# Product Change Notification

**Product Change Notification:** E-19-006031

<b>General Product Description:</b>
Economy power connector plug housing

# PCN for Economy power connector

## Test Result

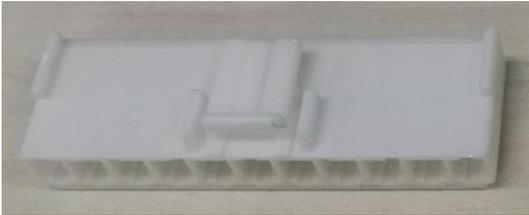
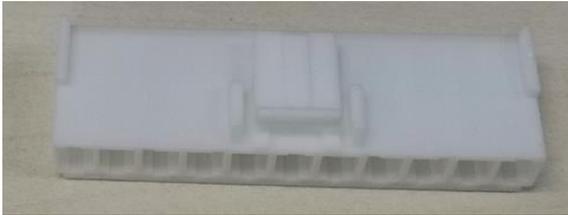
We have did performance test following product specification 108-5609, all performance related to resin meet spec., test report is 502- 106428
